SUBJECT: Forwards revised Cycle 2 stability test program, including commitment to take data at approx 42% rated flow near 100% rod line.

SUSQUEHANNA STEAM ELECTRIC STATION
REVISED UNIT 2 CYCLE 2 STABILITY TEST PROGRAM
PLA-2718 FILE R41-2

STABILITY TEST PROGRAM FOR SUSQUEHANNA UNIT 2 CYCLE 2

FIGURE 1

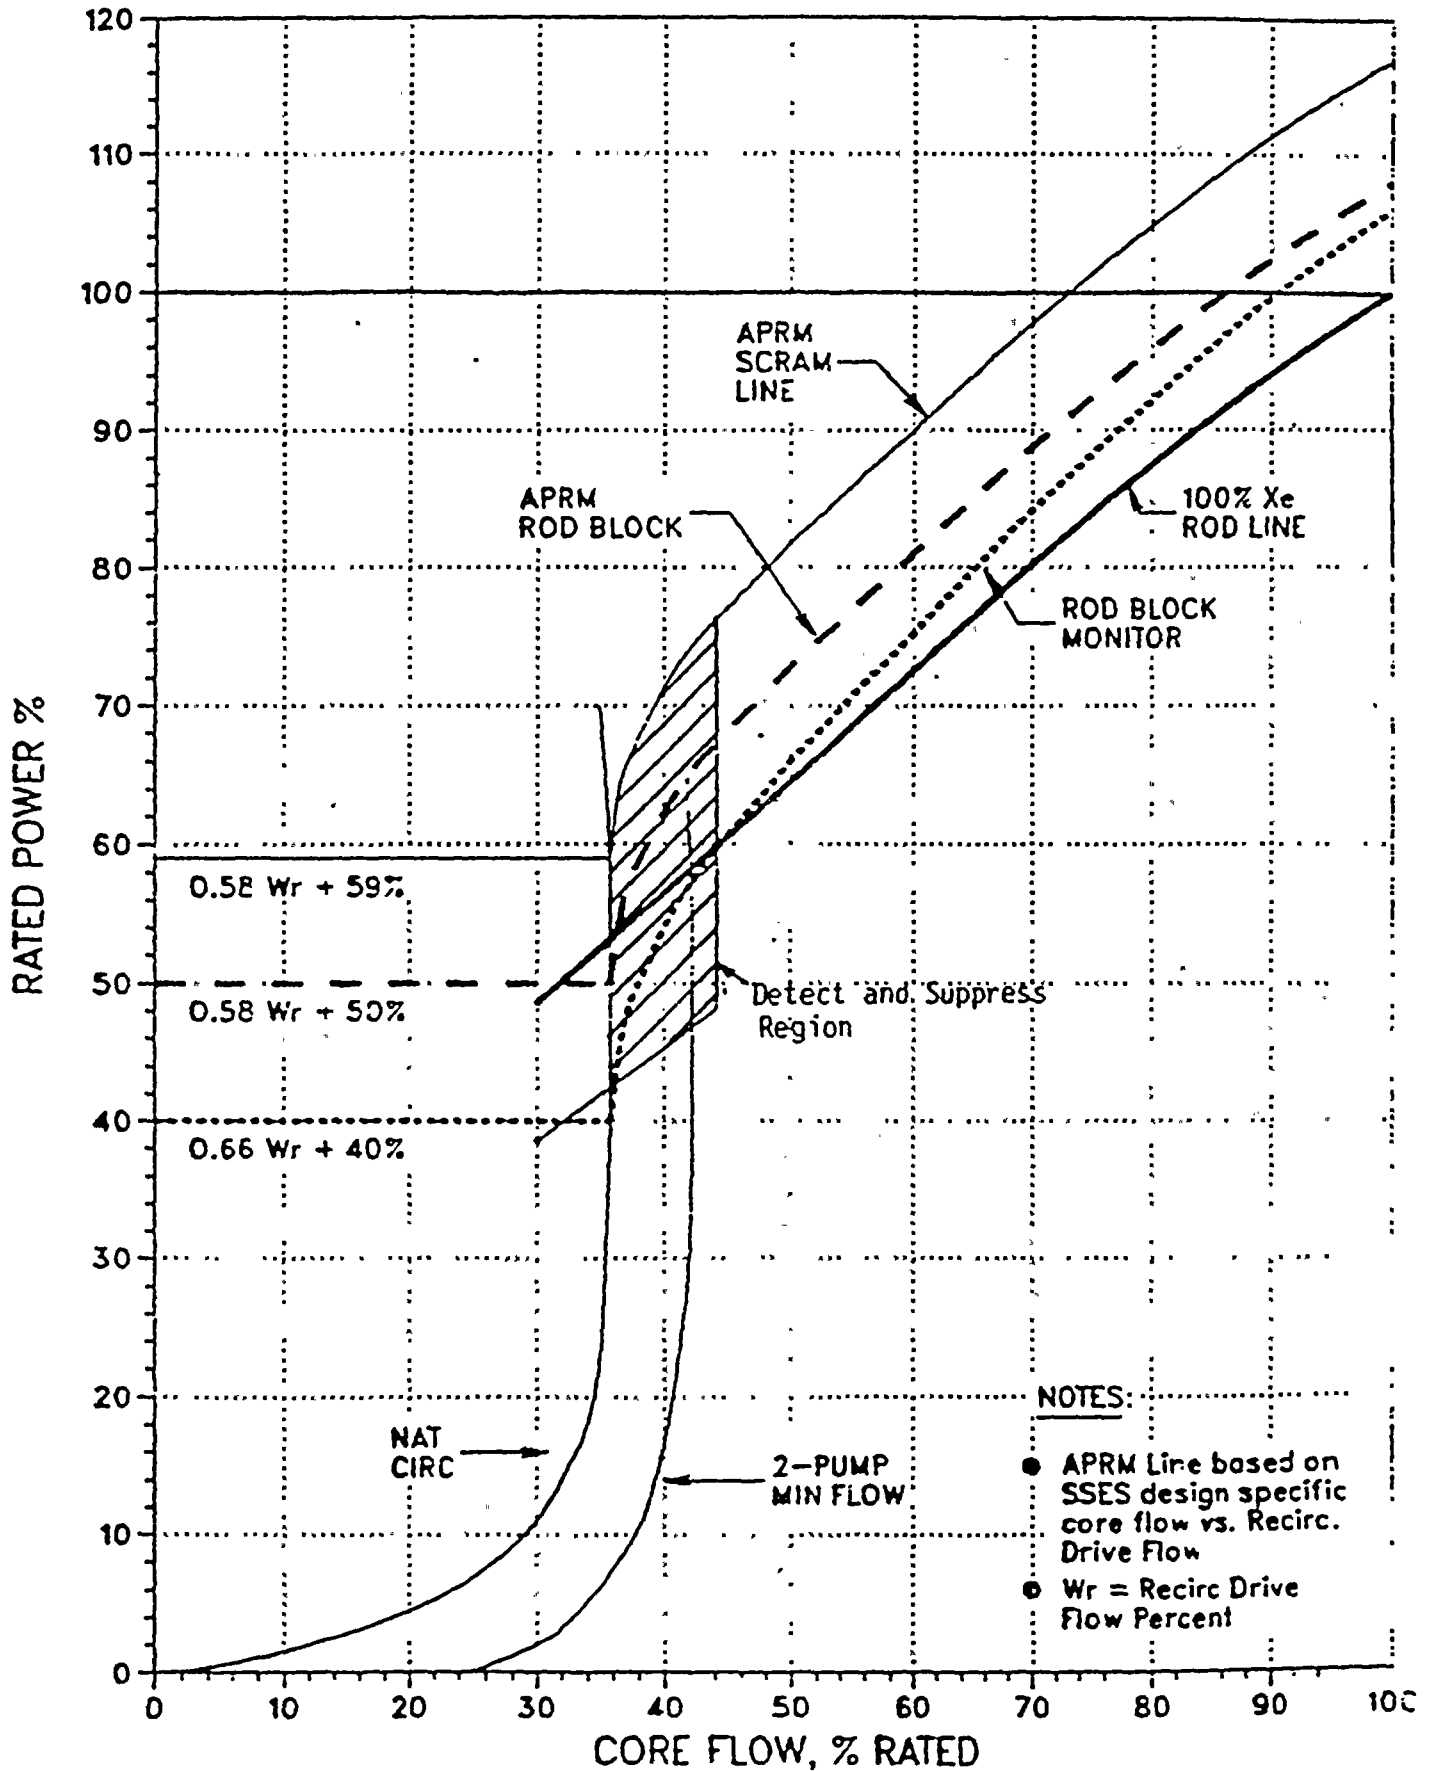
The data shall be taken during reactor startup and during single loop operation (SLO) following startup. Figure 1 shows the "detect and

suppress" area of operation in Susquehanna Unit 2. Data will be obtained at two test points on the power versus flow map. The first point to measure is the highest power to flow ratio attained during the normal startup. This point corresponds to the operating statepoint required by Technical Specifications which establishes the baseline noise level for stability monitoring, i.e., approximately 48% rated flow and the 100% rod line power. The second stability test point will be measured approximately one week later during single loop operation. Noise data is to be recorded during the SLO tests at approximately 42% rated flow and the 100% rod line power. No special rod motion or pressure perturbation will be made during the recording of the data.
